SUBJECT: CLINTON POWER STATION, UNIT NO. 1 - ISSUANCE OF AMENDMENT  
NO. 241 RE: REVISION OF DEGRADED VOLTAGE RELAY ALLOWABLE  
VALUES (EPID L-2021-LLA-0005)

The amendment revises Technical Specifications 3.3.8.1, "Loss of Power (LOP) Instrumentation," Table 3.3.8.1-1, "Loss of Power Instrumentation" degraded voltage relay allowable values.

SAFETY EVALUATION BY THE OFFICE OF NUCLEAR REACTOR REGULATION

CLINTON POWER STATION, UNIT NO. 1

Figure 1: DV ALs & ATSP with associated AVs (Reset & Dropout) relationships

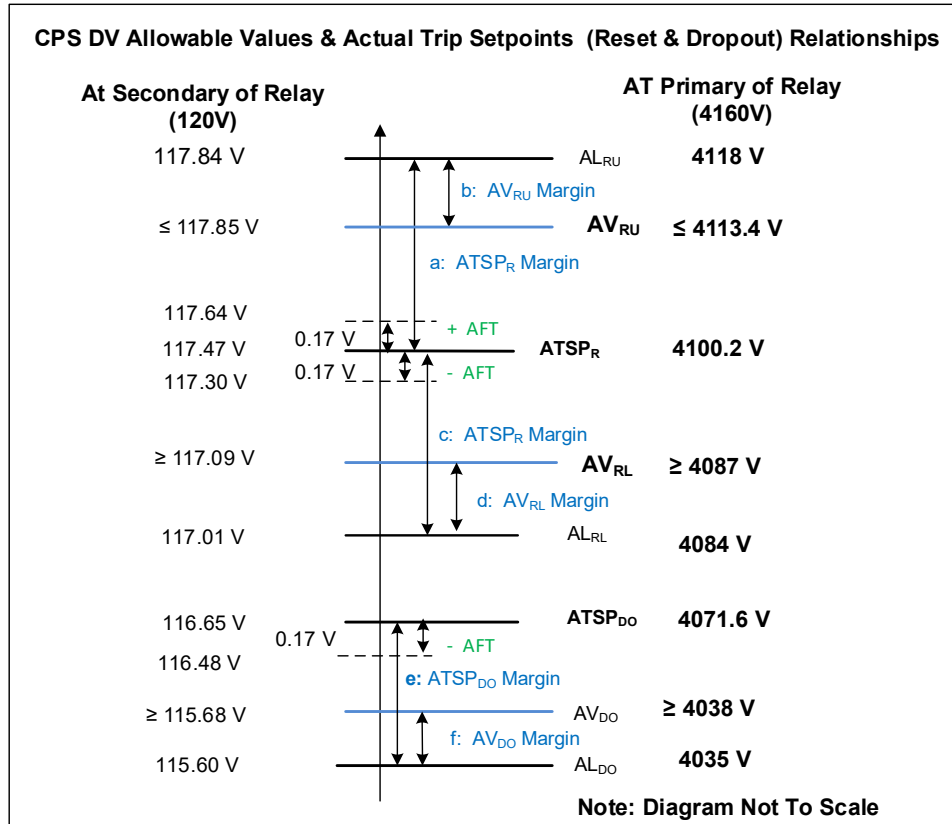
The NRC staff established the relationships between the DV ALs, NTSP, ATSP, and associated AVs of Buses A1\_AB; A1\_BC; B1\_AB; B1\_BC; C1\_AB; and C1\_BC. These relationships are reflected in Figure 1 below:

The NRC staff used the information in Table 1 through Table 3, Figure 1, and the guidance in RG 1.105, Revision 3, to independently calculate the margins between:

- Based on the information in Figure 1, the NRC staff verified that:

$$\begin{aligned} \text{ATSP}_R + \text{AFT} &< \text{AV}_{RU} \\ \text{ATSP}_R - \text{AFT} &> \text{AV}_{RL} \\ \text{ATSP}_{DO} - \text{AFT} &> \text{AV}_{DO} \end{aligned}$$

Therefore, the proposed AVs would assure that the trip signals will be initiated before  $ATSP_{RU}$  and  $ATSP_{DO}$  reach their AV values.

- Table 2 of this SE shows the AFT value is greater than the ST value. The AFT is greater than or equal to the as-left, or setting, tolerance and the application of the AFT does not result in a violation of an applicable limit. The nearest applicable limit to the ATSP is the AV. Figure 1 shows that the  $ATSPs \pm AFT$  do not reach the applicable AV. Therefore, this AFT is acceptable.

Therefore, the proposed revision of the CPS TS regarding the AV settings of the degraded voltages reset and dropout are acceptable.
